Comments from P. R. China on United States of America

Notification G/TBT/N/USA/1533

Federal Motor Vehicle Safety Standards; Occupant Crash Protection

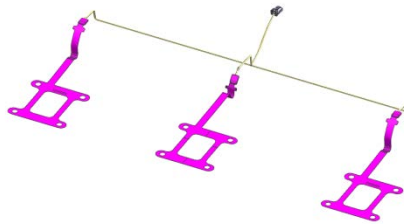
5. According to the telltale Characteristics, it is recommended to use the following figure (the main indicator icon is red), and it is suggested that the warning indicator can distinguish the specific unbelted seat.

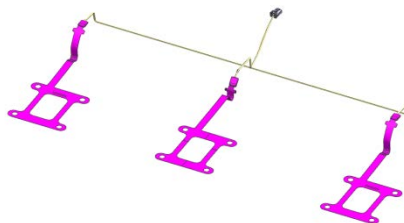
5. 针对信号装置特征，建议采用下图样式（主指示图标为红色），并建议提醒指示灯可以区分未系安全带的具体座位。
